IRN NO: <p style="text-align: center;">57000-0001</p>	<p>ISS PAYLOAD OFFICE IRN/PIRN/EXCEPTION FORM</p>	<p>(Page 1 of 28)</p> <hr/> DATE PREPARED: 5-31-01								
Doc. No., SSP 57000, Revision E Rev. & Title: Pressurized Payloads Hardware Interface Requirements Document		PIRN NO: 57000-NA-0205A, 57000-NA-0198A, 57000-NA-0203, 57000-NA-0208, 57000-NA-0222, 57000-NA-0235A								
(PIRN TITLE): <p style="text-align: center;">Incorporation of P/IRNs into SSP 57000</p>										
ORIGINATOR: Name: Tom Gallagher Agency: Boeing/TBE Phone: (281) 336-4074 Fax:	PIRN Type: <i>Check One</i> <input type="checkbox"/> Standard PIRN <input type="checkbox"/> Exception	<i>For Payload Office Use Only</i> <input type="checkbox"/> Exceedance <input type="checkbox"/> Deviation <p style="text-align: center;">Waiver</p>								
UTILIZATION CHANGE ENGINEER.: Name: Wade Geiger Agency: Boeing Phone: (281) 336-4284	SSCN/CR: SSCN 004176, SSCN 003970	RELATED PIRN NO.: N/A								
Agency Tracking No.:	SYSTEM/ELEMENT AFFECTED:									
REASON FOR CHANGE: (INCLUDE APPLICABLE ICAP NUMBER) SSCD #004176, SSCD# 003970										
PARAGRAPHS, FIGURES, TABLES AFFECTED (For PIRN use only)										
<table style="width:100%;

FIGURE 3.2.2.3-1 U.S. RPCM SOFT START/STOP CHARACTERISTICS

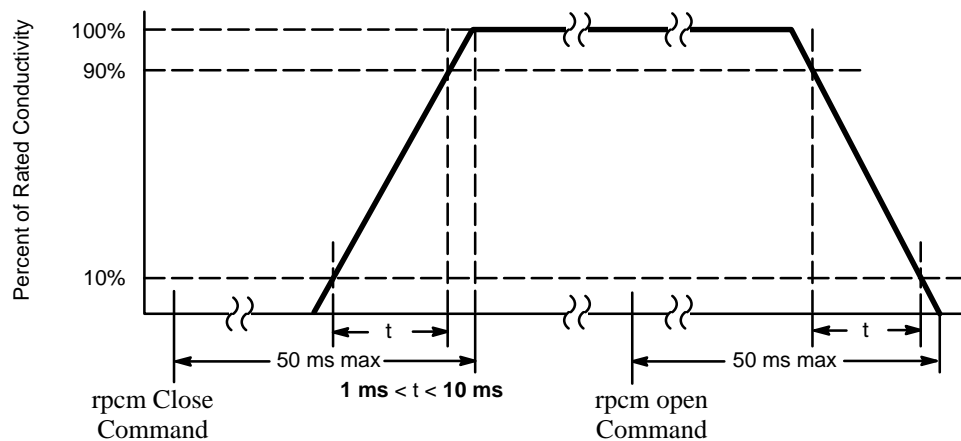
An integrated rack connected to Interface B or EPCE connected to Interface C shall initialize with the soft start/stop performance characteristics when power is applied, sustained, and removed by control of remote power control switches. The soft start/stop function, active only when the Remote Power Controller (RPC) is commanded on or off, is limited to 100 amps/ms, or less, by the RPC output. The response of the soft start/stop function is linear for resistive loads for 1 to 10 ms for U.S. LAB feeds, 1.5 to 5 ms for JEM 50 amp main feeds, 1.5 to 5 ms for JEM 25 amp main feeds, 0.1 to 5 ms for JEM 10 amp auxiliary feeds, and 0.1 to 50 ms for APM feeds between 10% and 90% of rated current level.

Note: Soft start/stop characteristics of U.S. standard RPCMs are shown in Figure 3.2.2.3-1.
